11511  
10 April 2014

**RESPONSE TO COUNCIL ISSUES IN JRPP REPORT FOR ITEM 2013SYE096 -  
SECTION 96 APPLICATION NO DA-2013/60/A  
20 LEVEY STREET & 34-36 MARSH STREET, WOLLI CREEK**

**Figure 1** – Revised apartment layout to converted commercial area

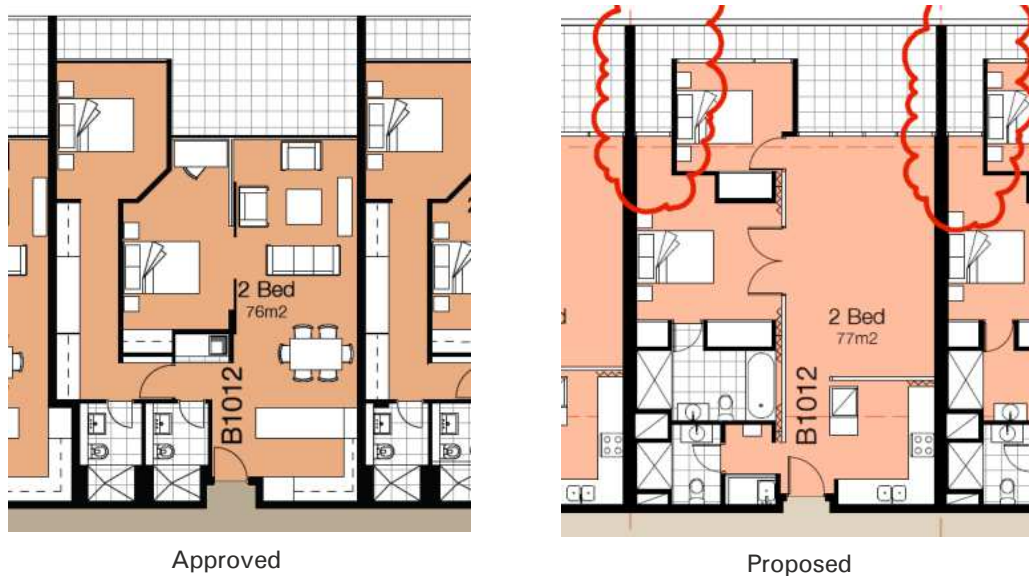
The proposal involves the conversion of the first floor commercial space within Building A into five new residential apartments. Two of the proposed five new apartments will be single aspect south facing, while the remaining three apartments will be oriented to the east, the south/east, and the south/west.

The layout of the single aspect south facing apartments has been amended to provide a more appropriate configuration in response to comments made by the DRP, including adjustments to the external façade line and reconfiguration of the bedrooms. This has resulted in a reduced depth in accordance with the RFDC Rule of Thumb and the improvement of the second bedroom so that both bedrooms have external facing windows and access to daylight (Refer **Figure 1**). In light of these changes the apartments will be afforded an appropriate level of amenity and are considered to be acceptable as:

- Three of the five proposed apartments have northern, eastern and western facing facades and balconies;
- All apartments that include a south orientation have oversized balconies that are well in excess of the RFDC 8m<sup>2</sup> requirements;
- All apartments have generously sized living areas and bedrooms that allow for ample indoor space and multiple furniture configurations;
- All apartments will have access to numerous communal facilities (gym, meeting room, pool, rooftop landscaped area) and nearby public open space that is located immediately adjacent to the site.
